CIVA Free Known Programme 1 Power Intermediate / Yak-52, Advanced an Unlimited 2018

Guidance for competitors

Advanced power category

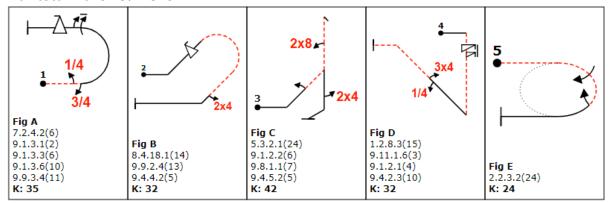
Note 2: Unlimited power Figure 'E' 2.3.6.1 is within the revised 2018 CIVA Section 6 Part 1 para 2.2.1.8 versatility range. **Note 3:** In Advanced figure A the final 1½ rolls and the flick roll should be performed in the <u>same</u> direction. These two rolls have previously been shown in opposite directions, which was incorrect.

Unlimited power category

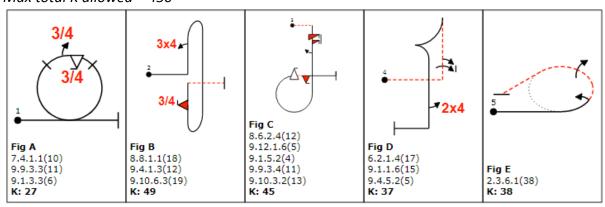
Note 1: Unlimited power Figure #3 has been revised from the original version

- ullet The duplicated 2x4 roll (9.5.4.2) after the spin is now changed to a ½ roll (9.1.5.2)
- The flick-roll pair is now set to opposite directions per Aresti regulations
